# Lucan Active Travel Overview & Update

## Canal Loop Scheme

- Project overview and update
- Proposed changes

Drawing Title: **Options Concept Review**

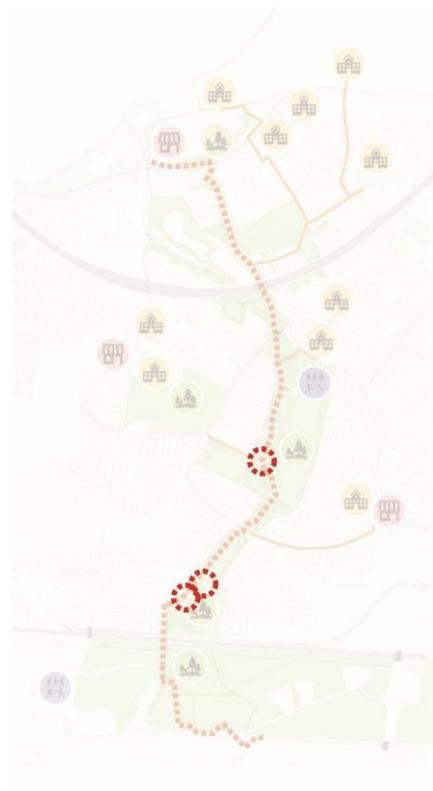
**Notes Option 1:Part 8 Planning**  
4m Average Width (3m clear)  
218m Boardwalk Length  
1160 Sqm of Trees Removed

Drawing Title: **Options Concept Review**

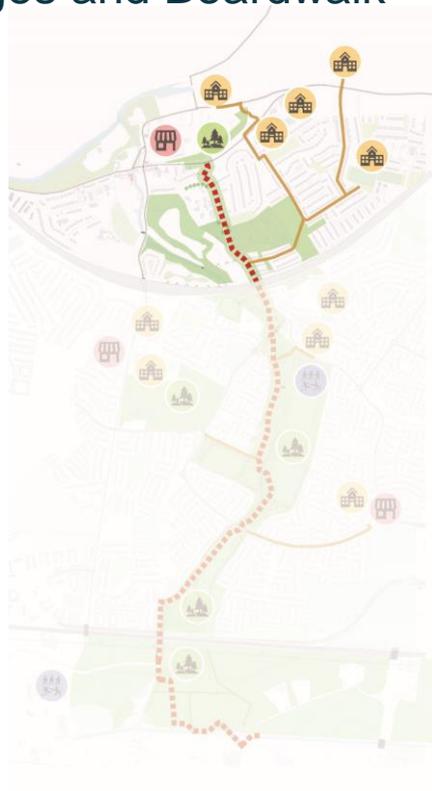
- Notes Option:**  
 4m Average Width (3m clear)  
 120m Boardwalk Length  
 95m of two-way cycle track  
 480 Sqm of Trees Removed  
 8 Parking spaces relocated

# Parking Relocation

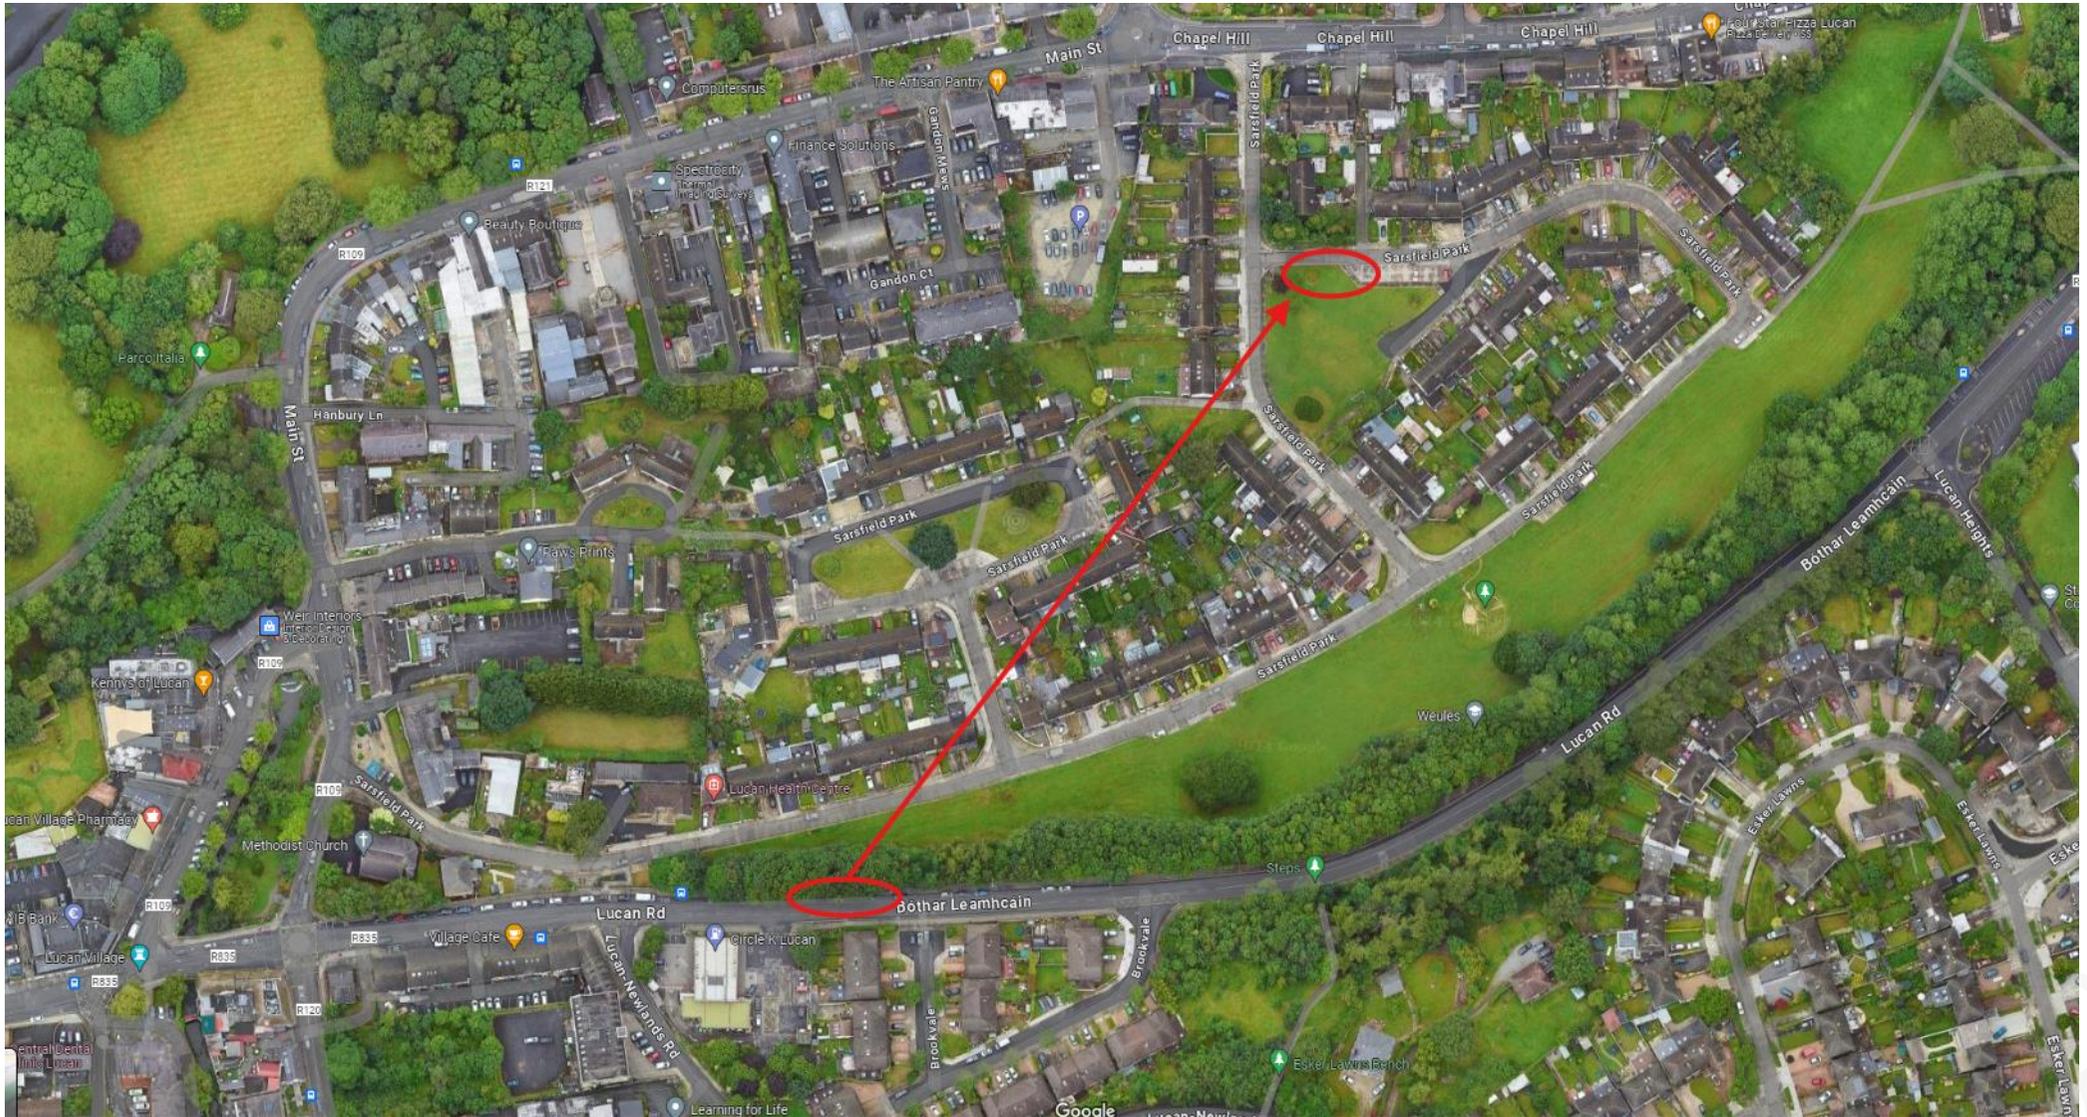
- The proposed changes will significantly reduce the impact (environmental and construction) in Sarsfield Park.
- 8 parking spaces would be relocated
